**Agenda Item 3**  
**250 Butler Drive**  
**New House with an Attached Garage, Hardscape, a Cabana and a**  
**Conceptual Landscape Plan on a Vacant Lot**

## 250 Butler Drive

**Consideration of a new house with an attached garage, hardscape, a cabana, and a conceptual landscape plan proposed on vacant property.**

### **Staff Review of Standards – Evaluation, Comments, and Recommendations**

# EAST AND WEST ELEVATIONS

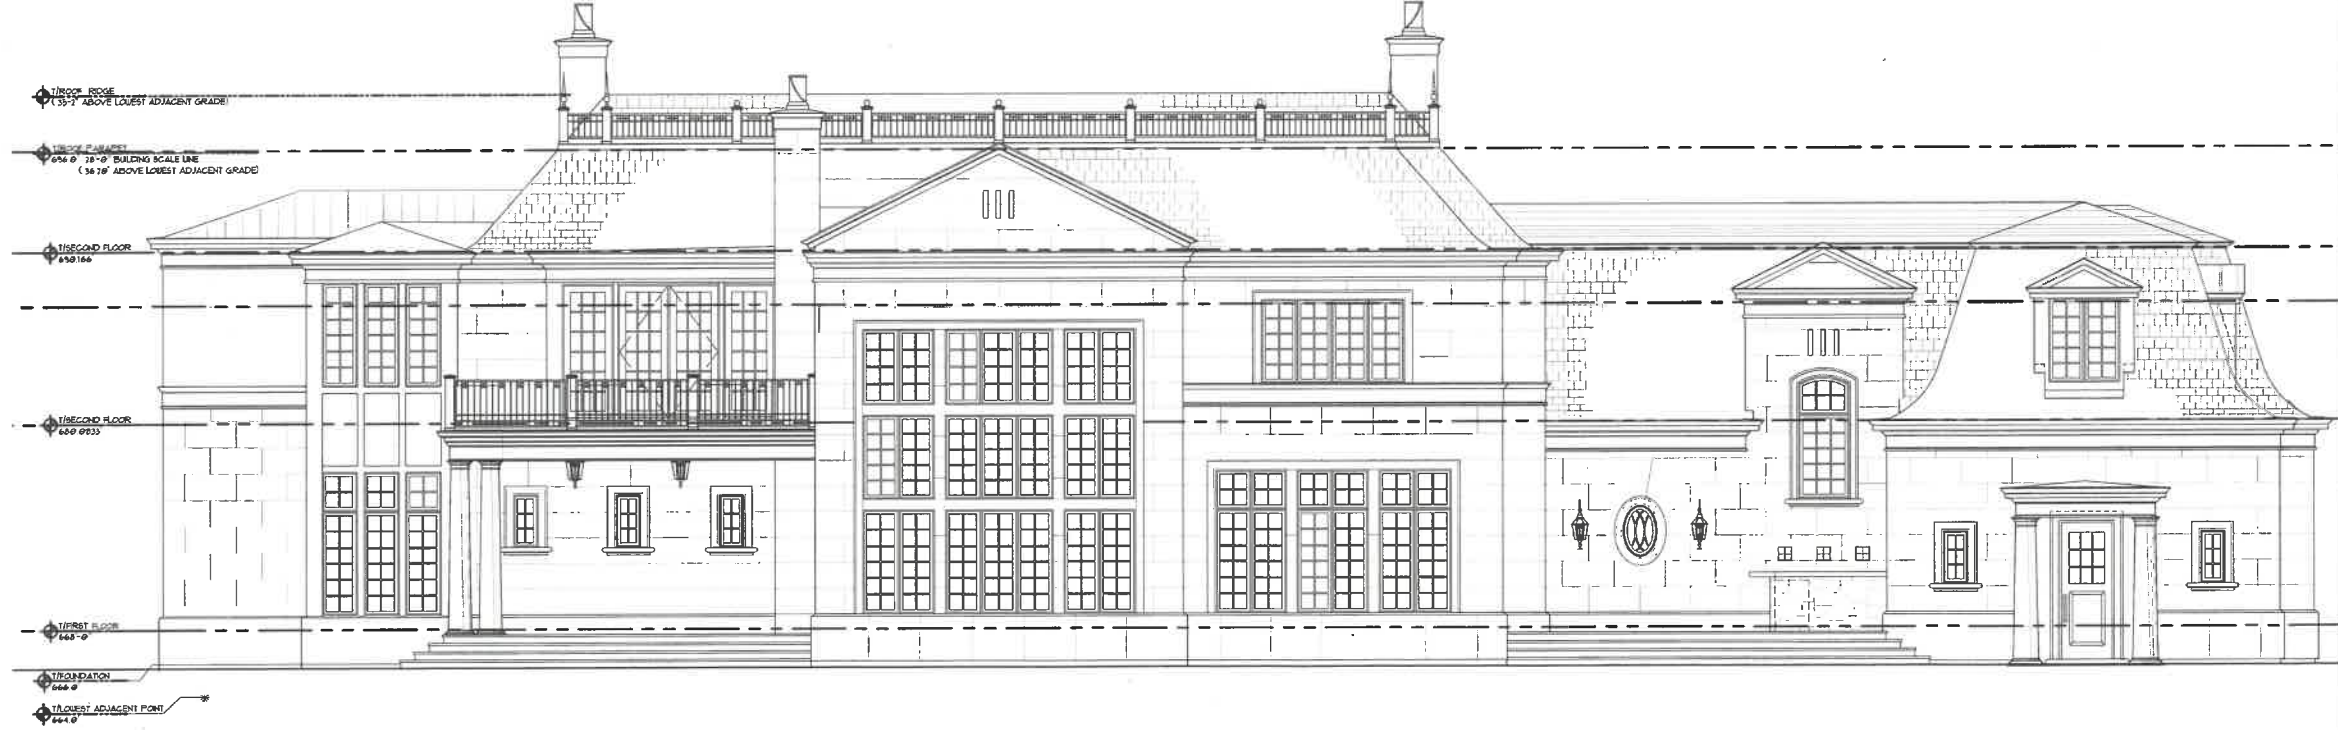
The use of four oval dormers on the front elevation appears excessive. Removal of the two dormers directly flanking the center gable would allow the remaining two to provide an appropriate accent.

**Staff Recommendation:** Consider two, rather than four oval dormers on the east elevation.

1. Prior to the submittal of plans for permit, consider eliminating two of the four oval dormers on the east (front) elevation.
2. At the time of submittal for permit, include the following:

# CONCEPTUAL LANDSCAPE PLAN

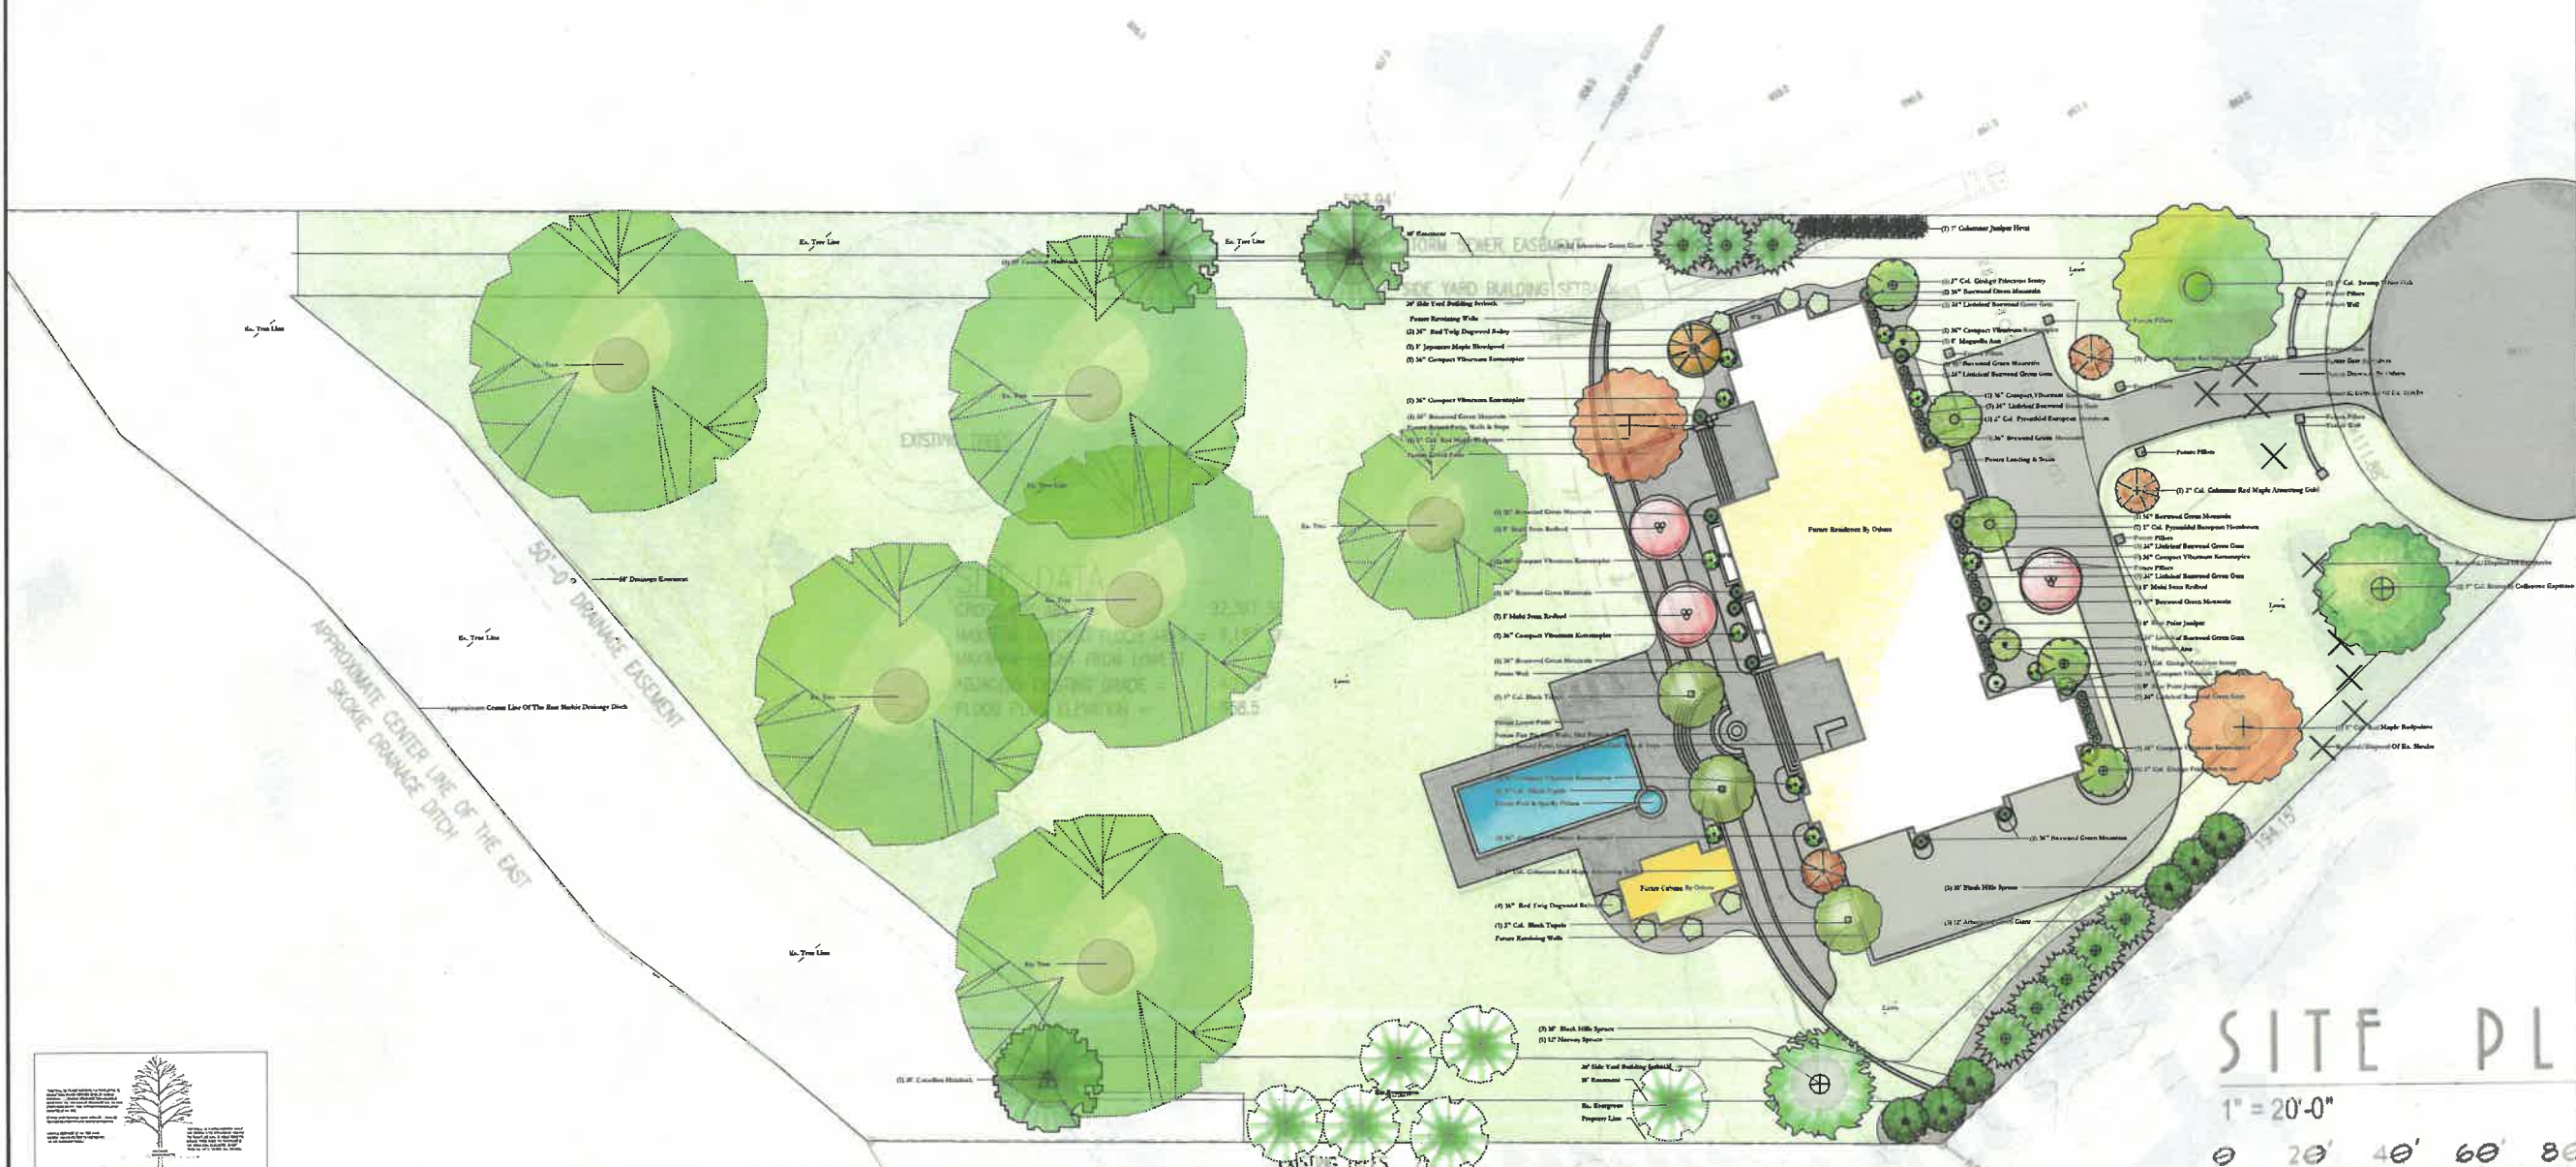
The proposed conceptual landscape plan displays sufficient screening and adherence to the minimum criteria for new houses. However, a tree removal plan has not yet been submitted demonstrating the total number of inches being removed and replaced. This will be evaluated, along with adherence to the minimum criteria, when the official landscape plan is submitted. In requiring replacement tree inches, consideration will be given to any limitations imposed on the lot due to the flood plain.

- a. A tree plan shall be submitted and will be subject to review and approval by the City's Certified Arborist. The plan shall identify trees proposed for removal, and trees identified for protection and preservation.
- b. A plan shall be submitted identifying the location of tree protection fencing to be installed prior to the start of construction and describing pre and post construction treatments proposed to increase the chances of long term survival of the trees intended for preservation which are located close to construction activity.
- c. Prior to the issuance of a building permit, a detailed landscape plan shall be submitted and will be subject to review and approval by the City's Certified Arborist. The plan shall, at a minimum, meet the landscaping standards for new residences detailed in the Code and all required

# FRONT (EAST) ELEVATION

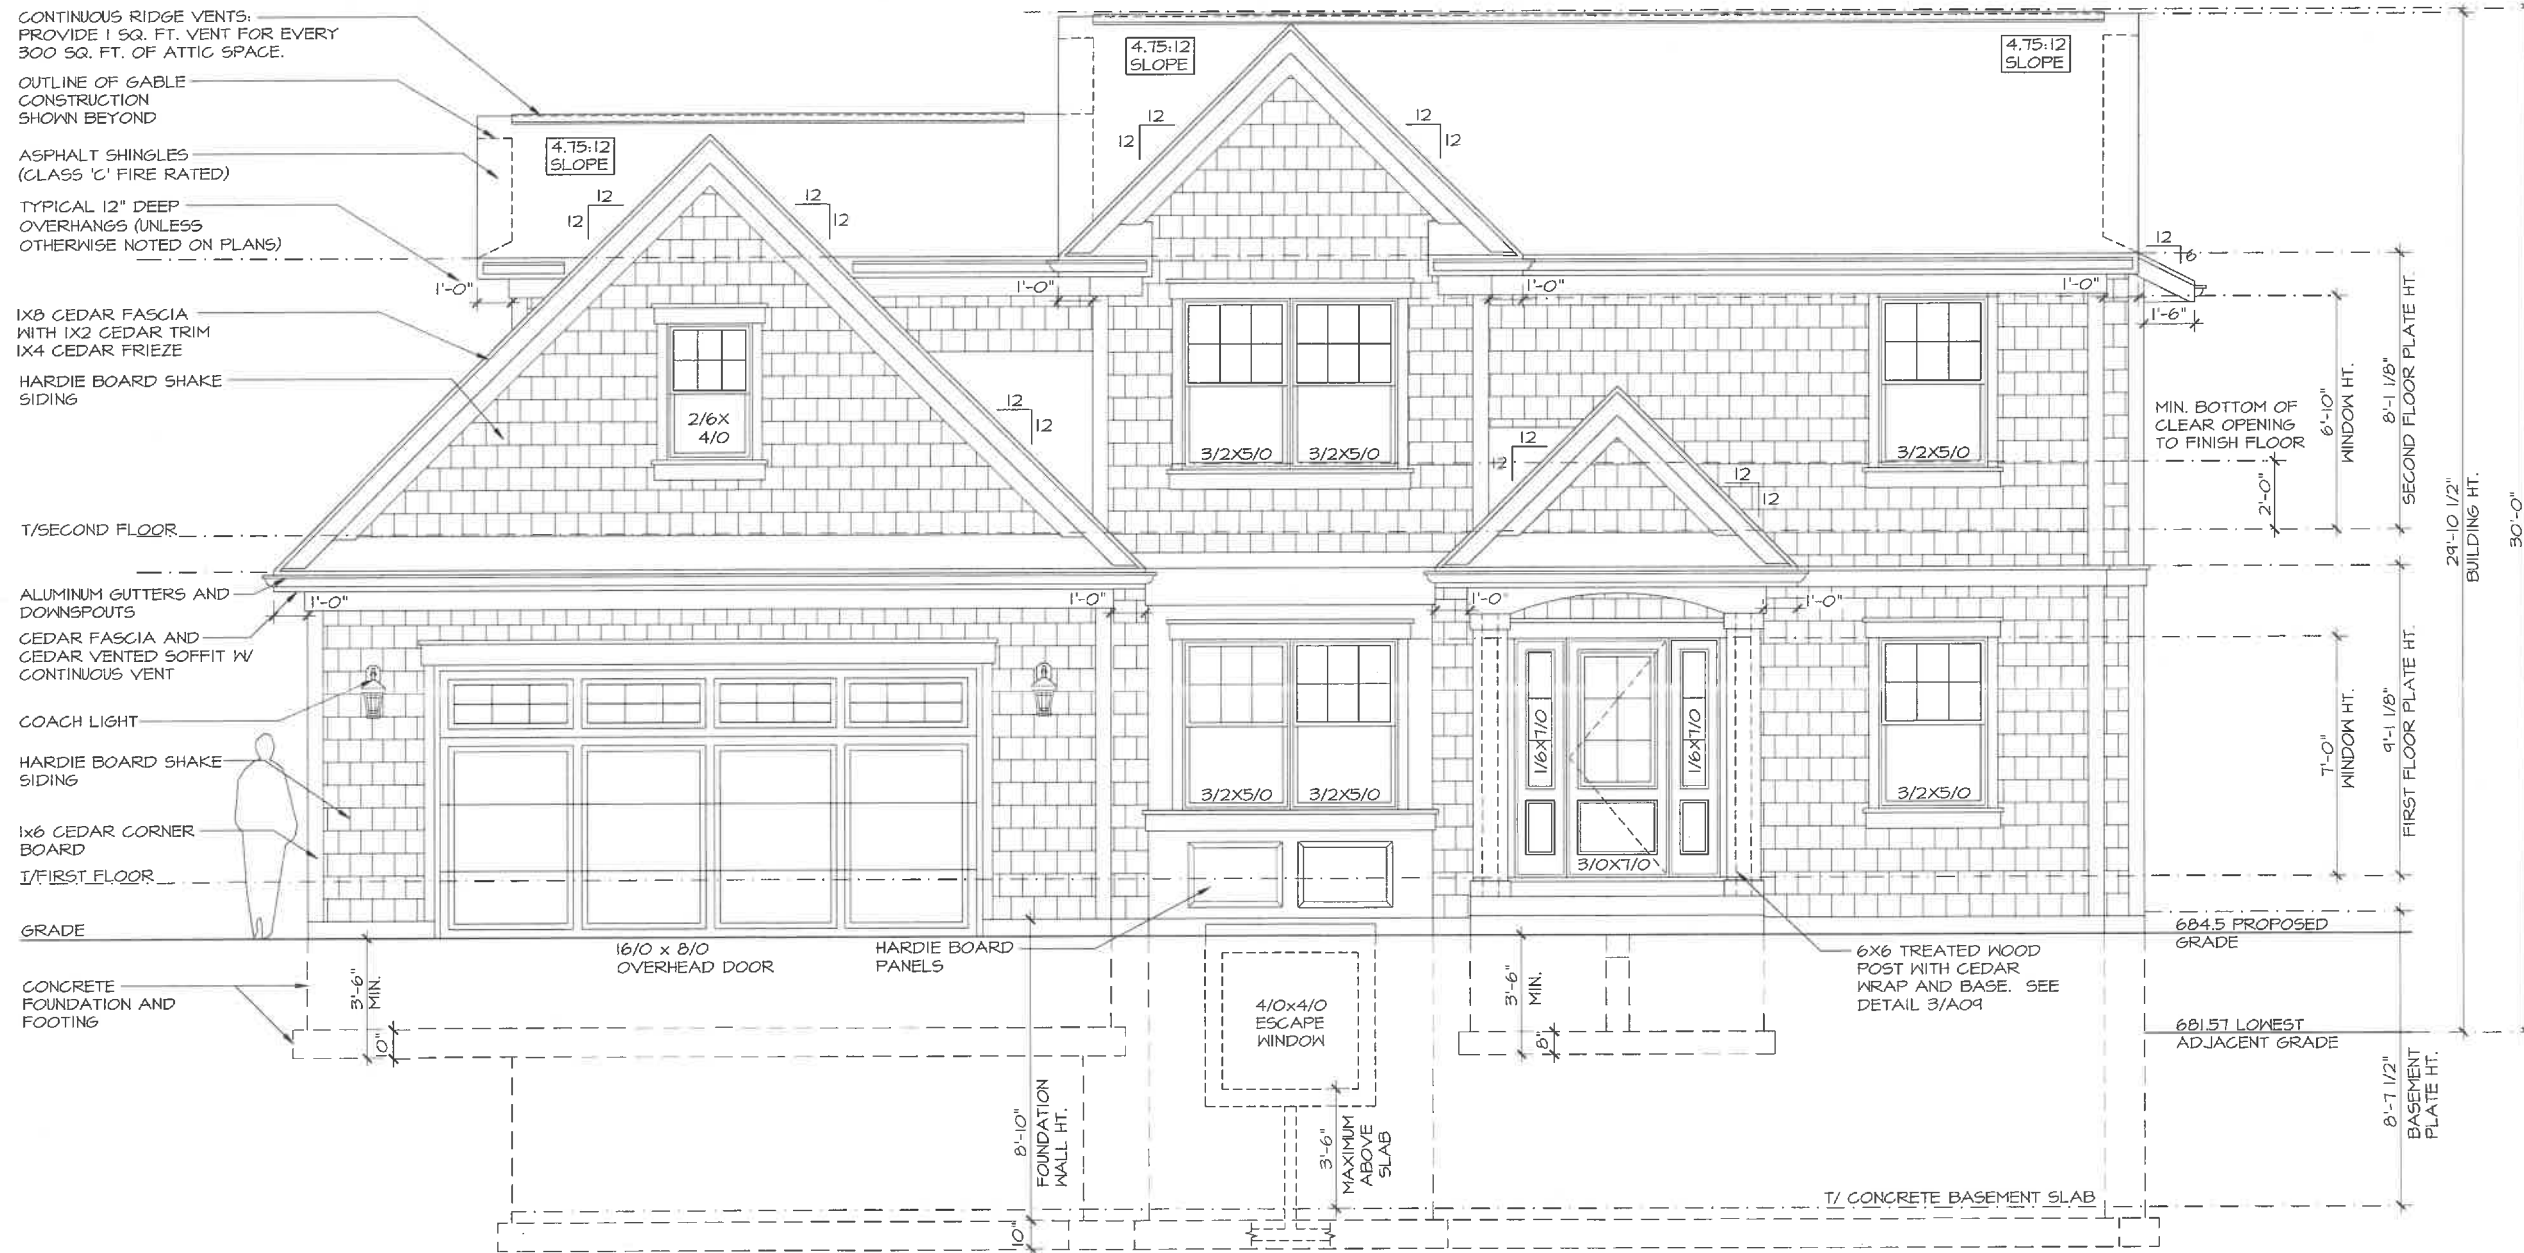
1. Prior to the submittal of plans for permit:
  - a. Study and refine the porch arch and align the fascia board on the east elevation.
  - b. Clarify the hardscape materials.
2. All modifications to the plans including those detailed above and any others made in response to Board direction or as the result of final design development, shall be clearly called out on the plans submitted for permit. Staff is directed to review any changes, in consultation with the Chairman as appropriate, to determine whether the modifications are in conformance with the Board's direction and approval prior to the issuance of any permits.
3. Prior to the issuance of a building permit:
